Notice of Proposed Amendment 2017-04

Regular update of aerodrome rules

CS-ADR-DSN — Issue 4

RMT.0591

Figure N-4. Mandatory instruction signs

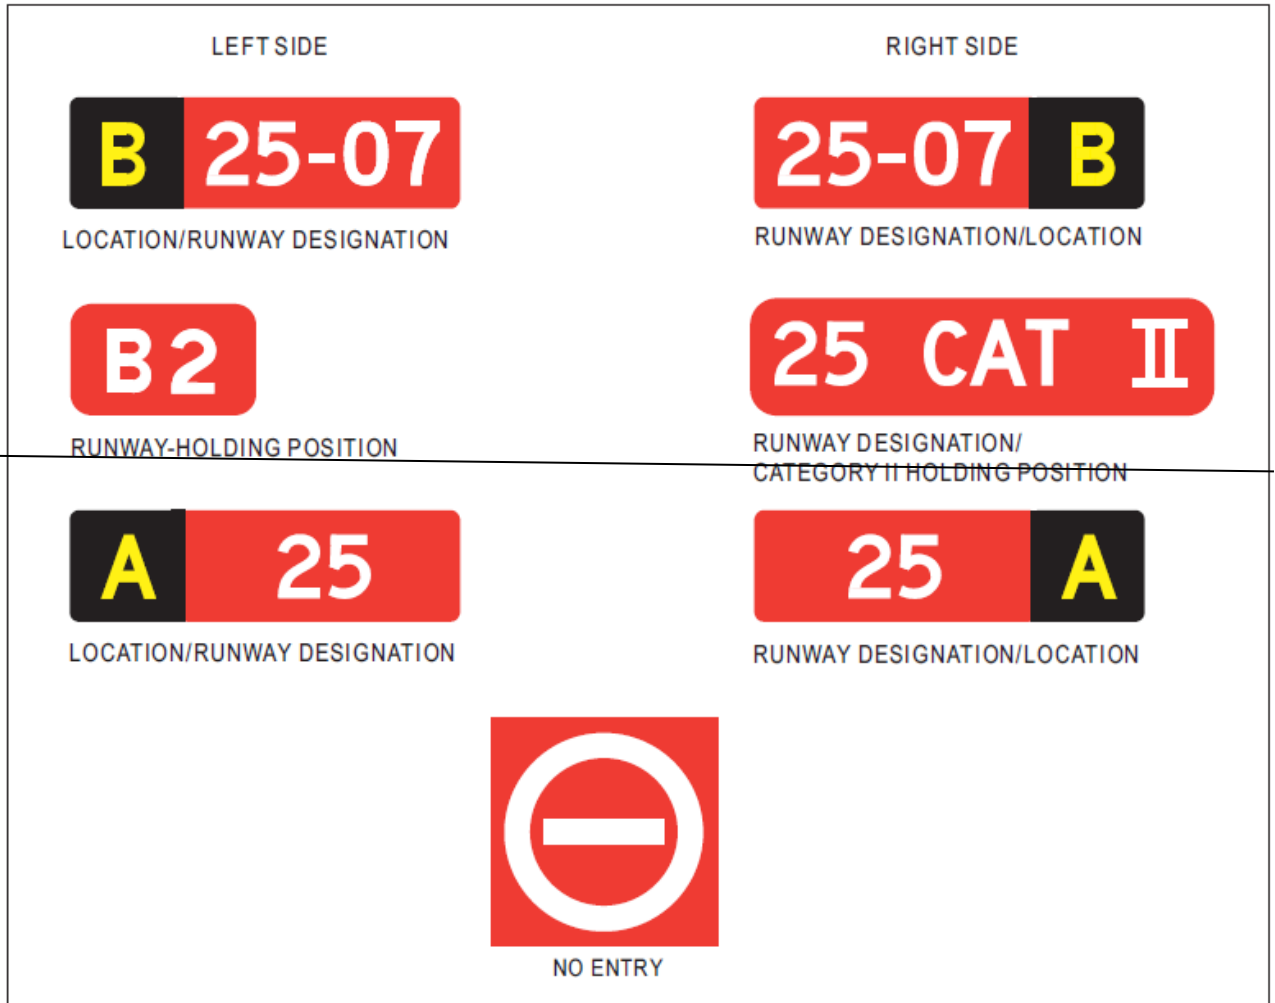
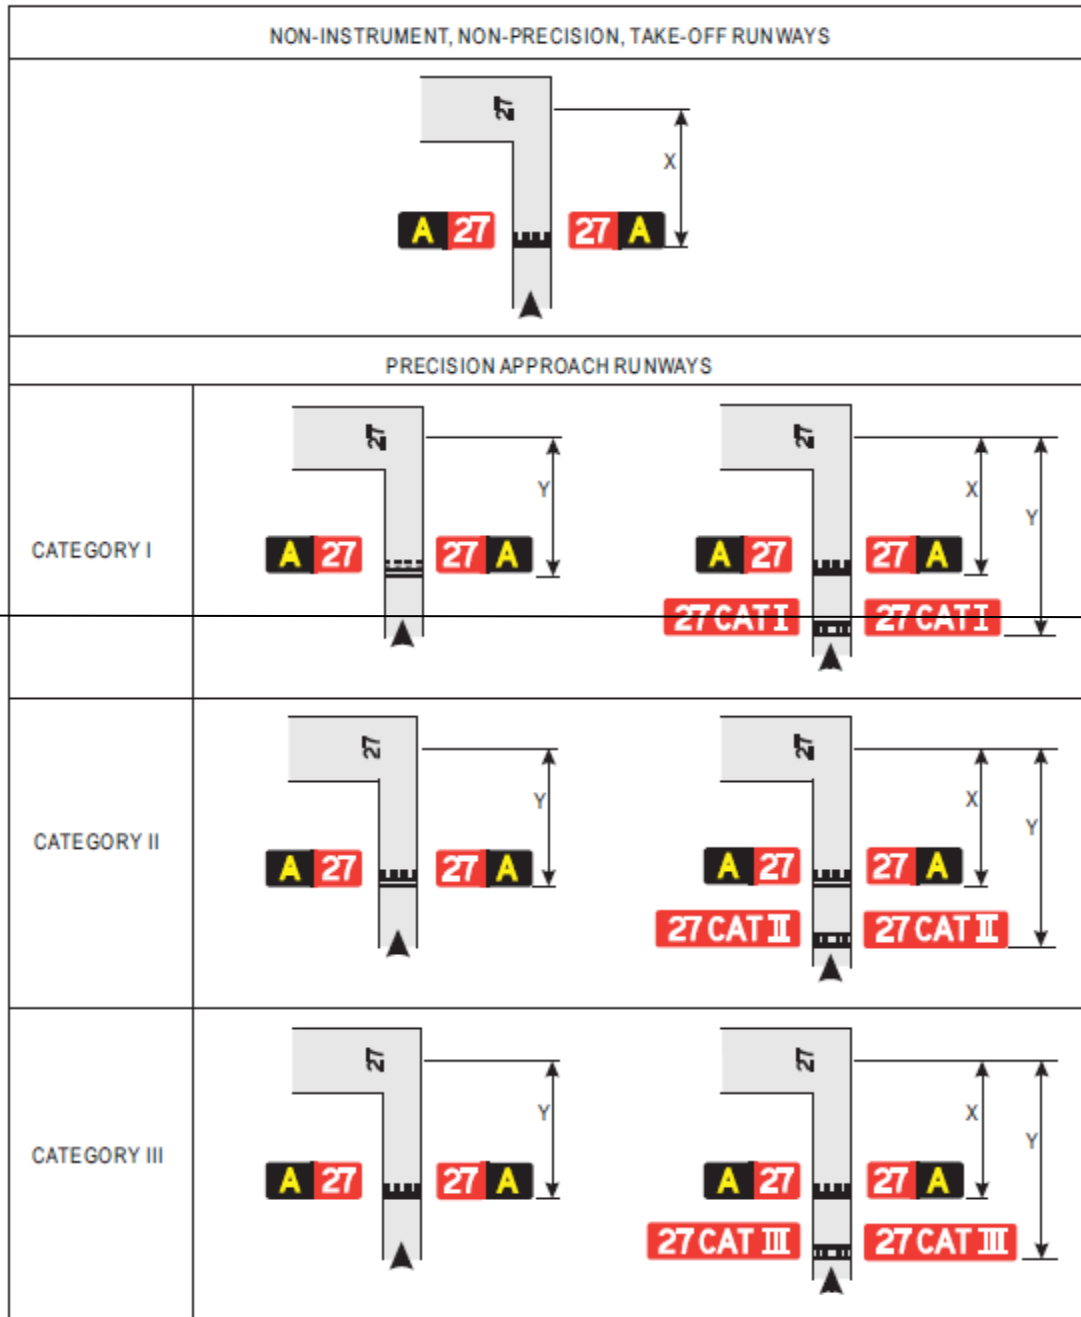
CS ADR-DSN.N.780(d) has been updated in accordance with ICAO Annex 14, ‘Aerodromes’, Volume I, Amendment 13-A, by deleting text in columns ‘Inscription/Symbol’ and ‘Use’, and adding the updated Figure N-4.

[Editorial note: Figure N-4 is deleted:]

[Editorial note: new Figure N-4 is added:]

Figure N-5. Positions of signs at taxiway/runway intersections

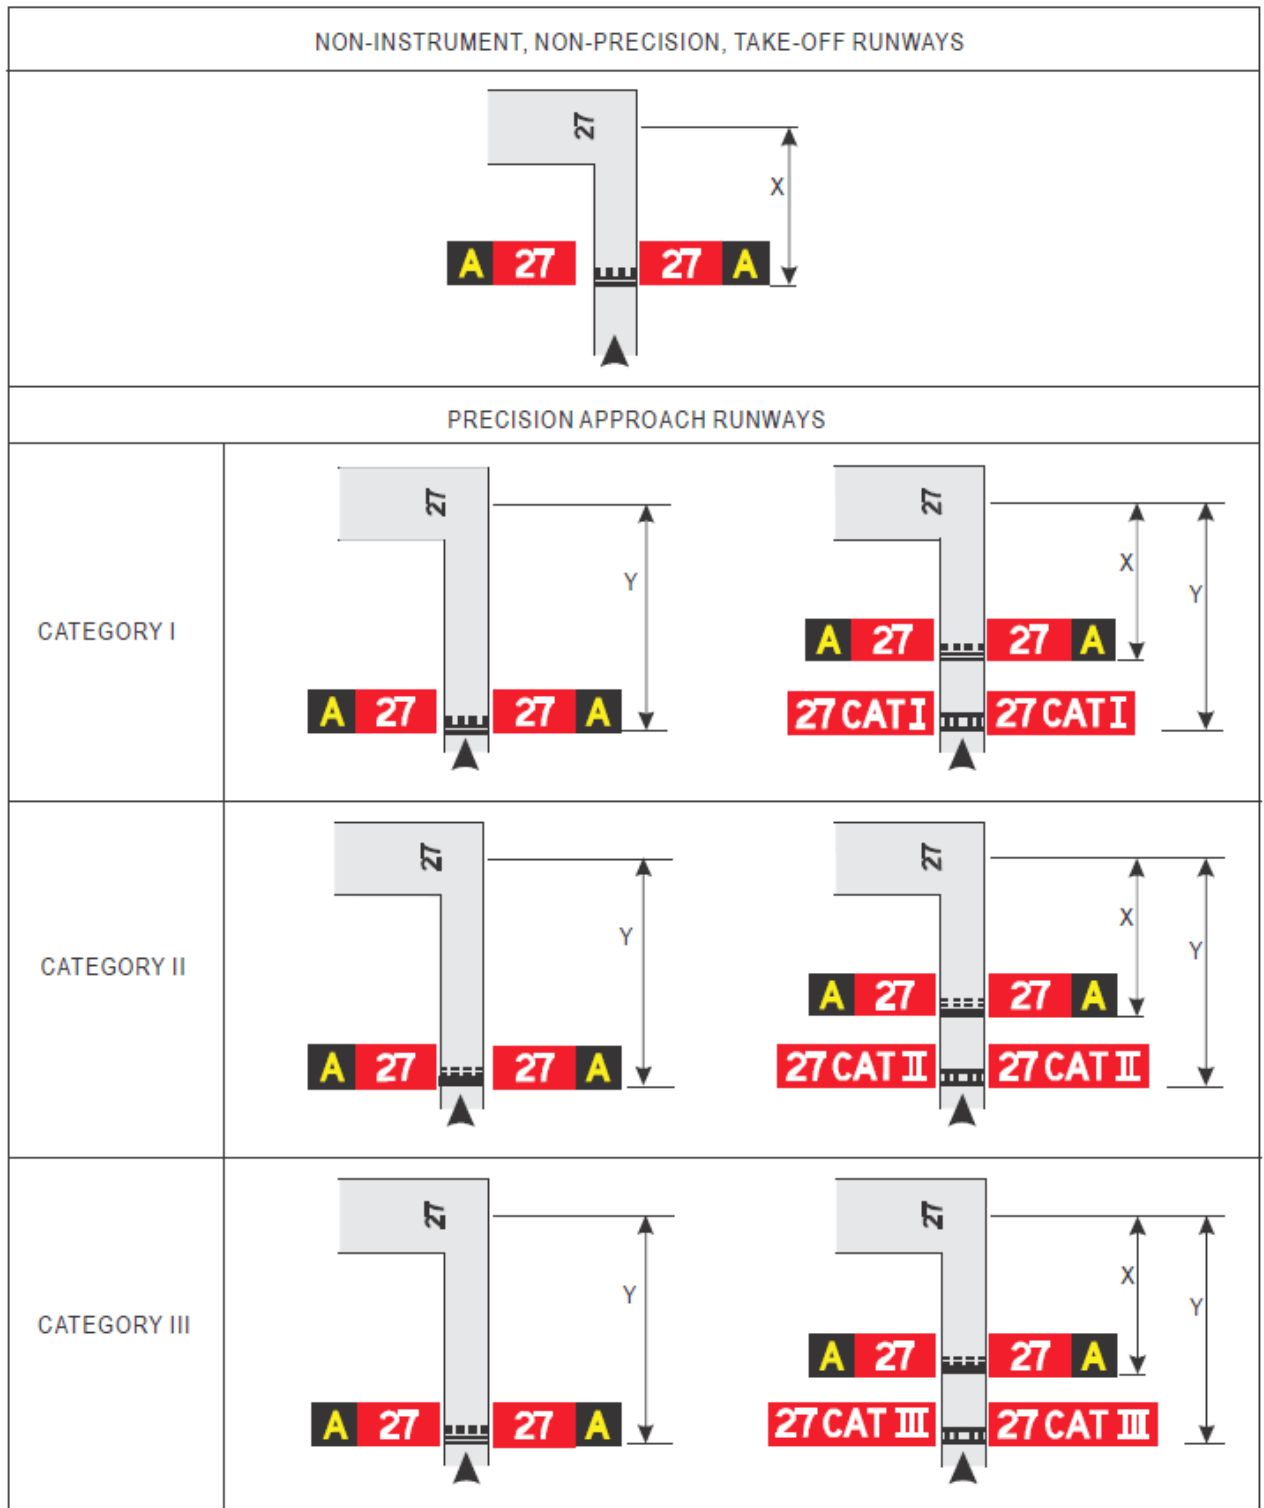
Figure N-5 has been replaced with the new Figure N-5 and updated with a note.

[Editorial note: Figure N-5 is deleted:]

[Editorial note: new Figure N-5 is inserted:]

Note: Distance X is established in accordance with Table D-2. Distance Y is established at the edge of ILS/MLS critical/sensitive area

Figure N-6. Information signs

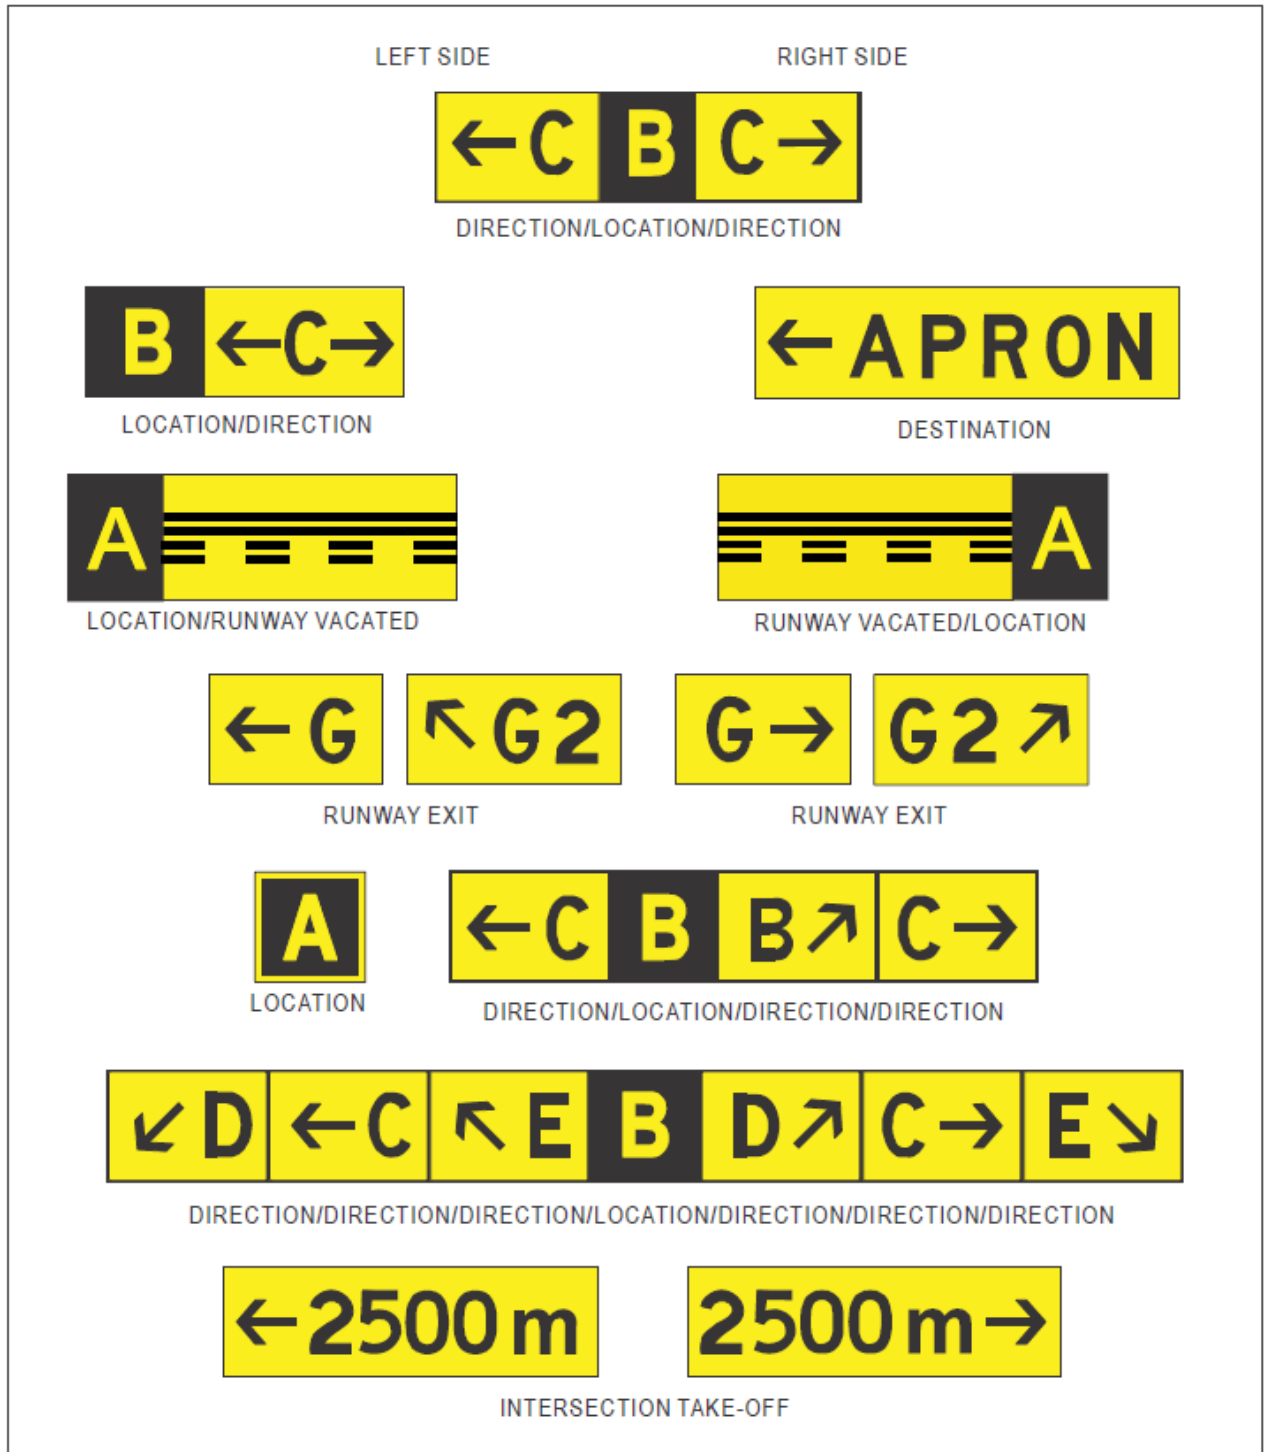
Figure N-6. ‘Information signs’ has been replaced by a more appropriate new one.

[Editorial note: Figure N-6 is deleted:]

[Editorial note: new Figure N-6 is added as follows:]

Figure U-1A. Colours for aeronautical ground lights (filament-type lamps)

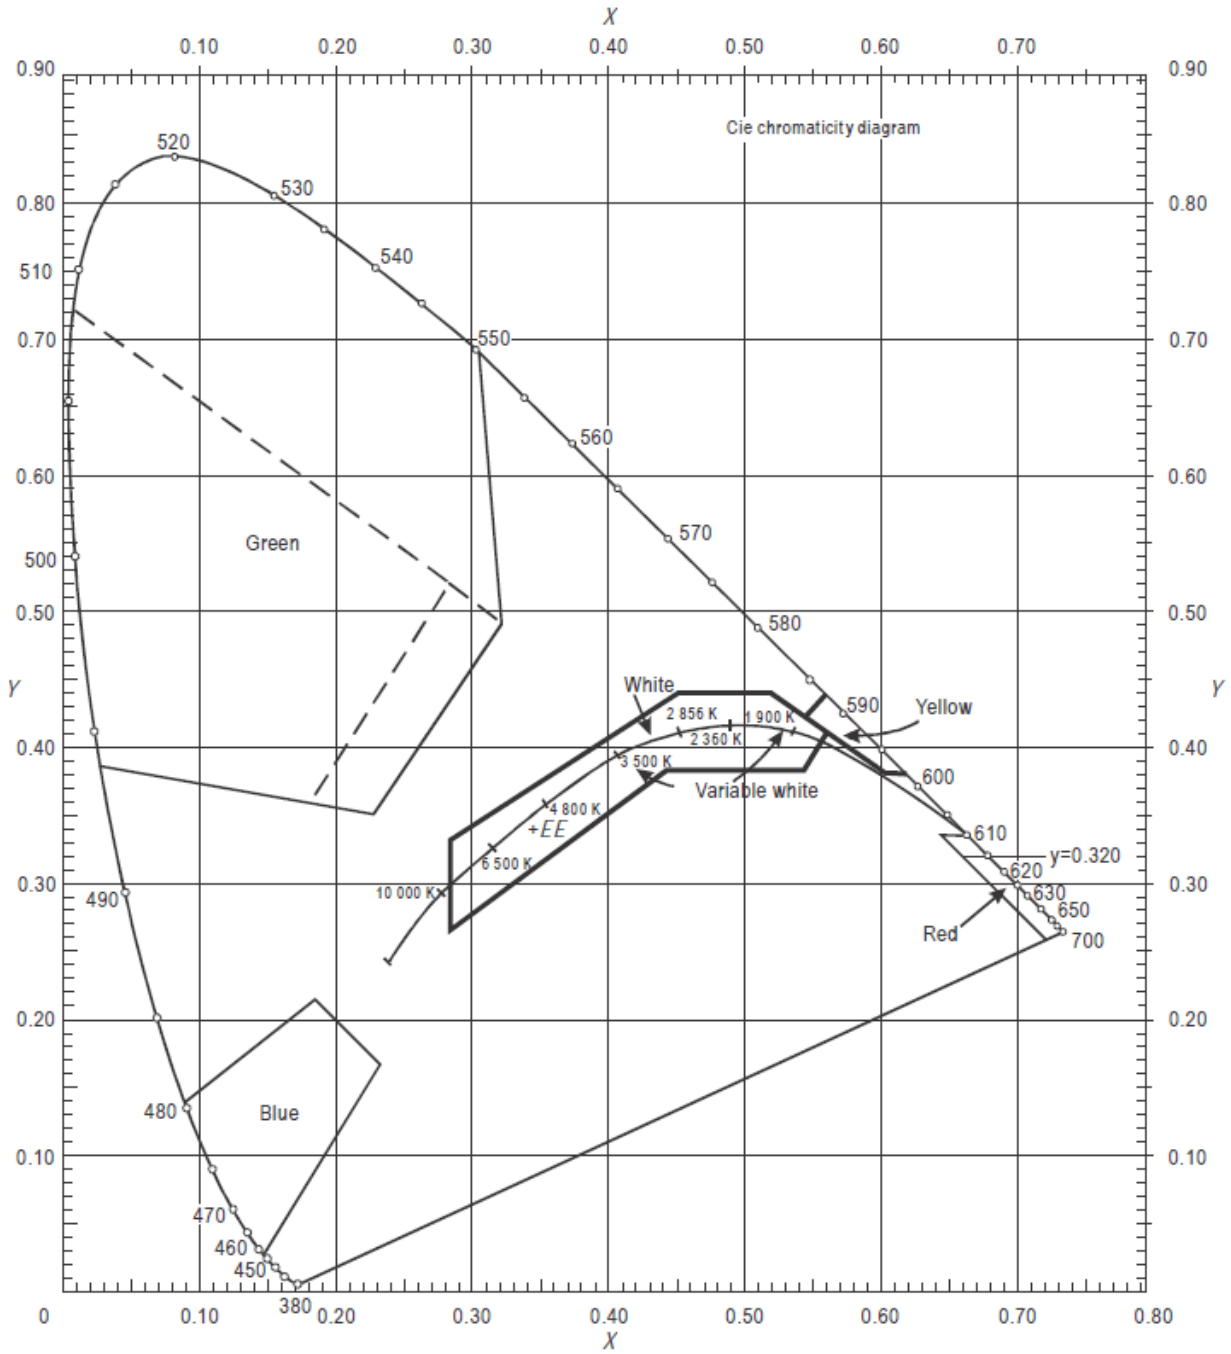
Figure U-1 has been replaced with Figures U-1A and U-1B in accordance with ICAO Annex 14, 'Aerodromes', Volume I, Amendment 13-A.

[Editorial note: Figure U-1 is deleted:]

[Editorial note: new Figure U-1A is added as follows:]

Figure U-1B. Colours for aeronautical ground lights (solid state lighting)

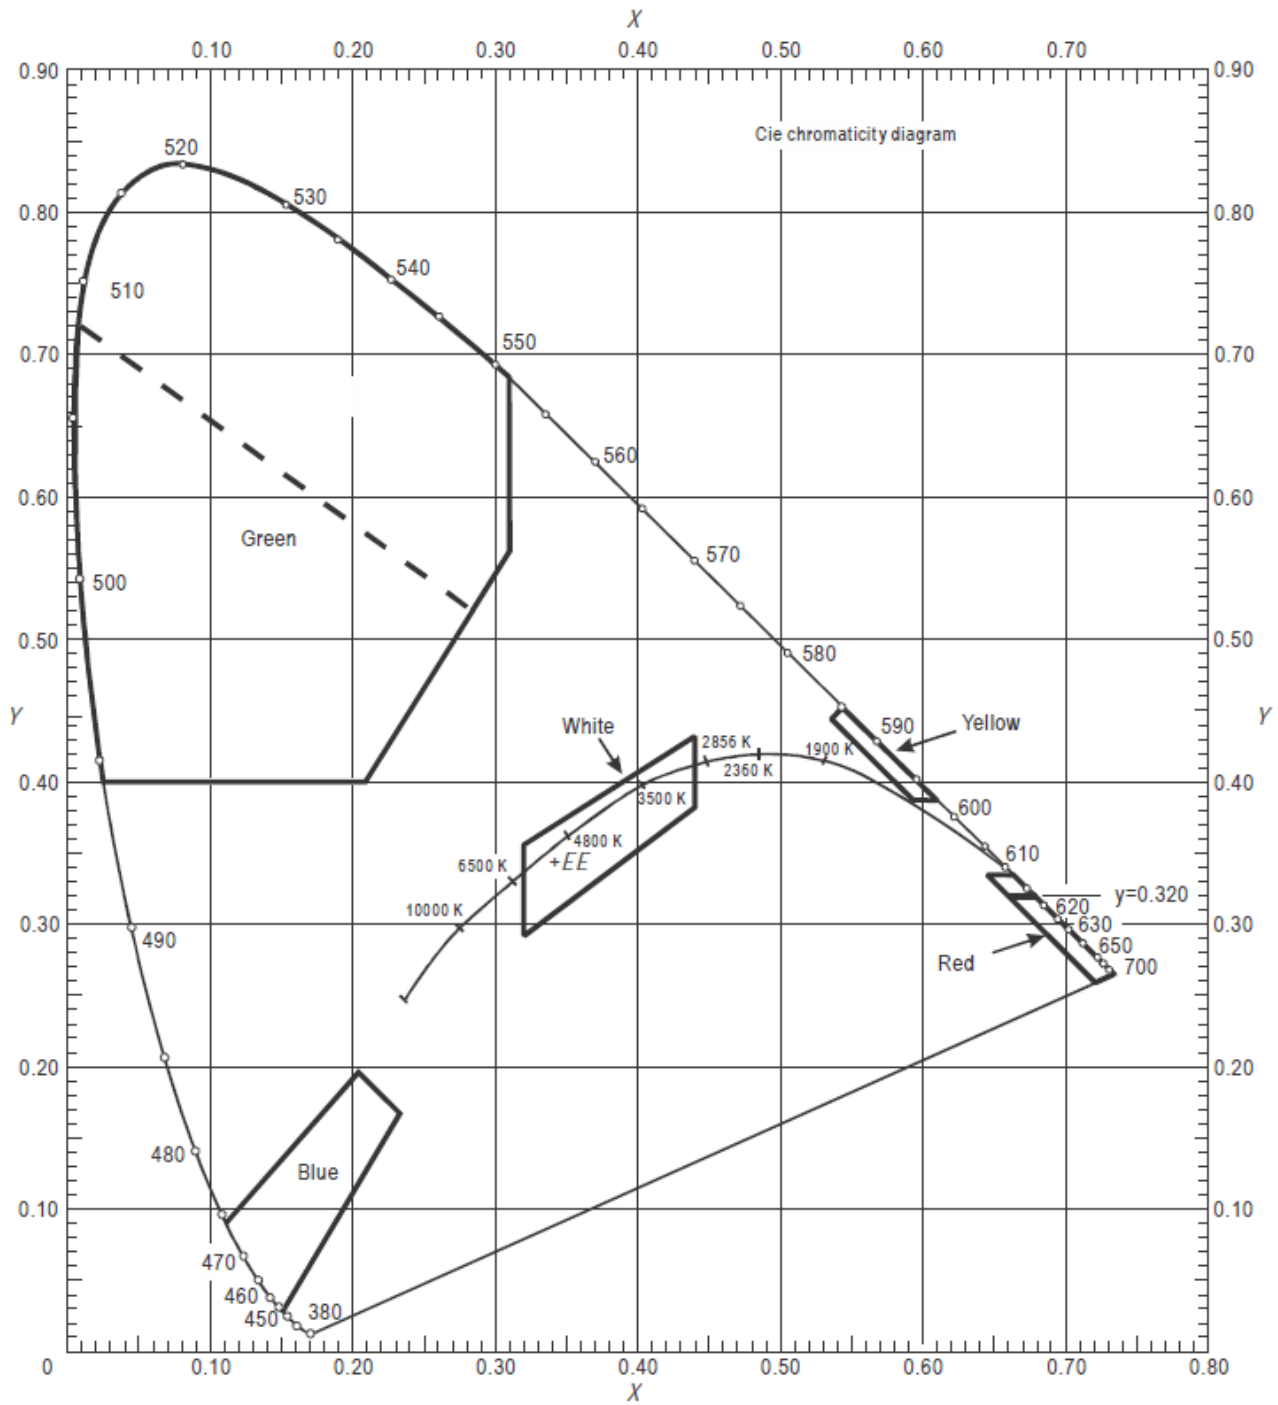
The new (d) has been created in accordance with ICAO Annex 14, 'Aerodromes', Volume I, Amendment 13-A to provide the chromaticity characteristics of aeronautical ground lights with solid state light sources, e.g. LEDs.

[Editorial note: new Figure U-1B is added as follows:]
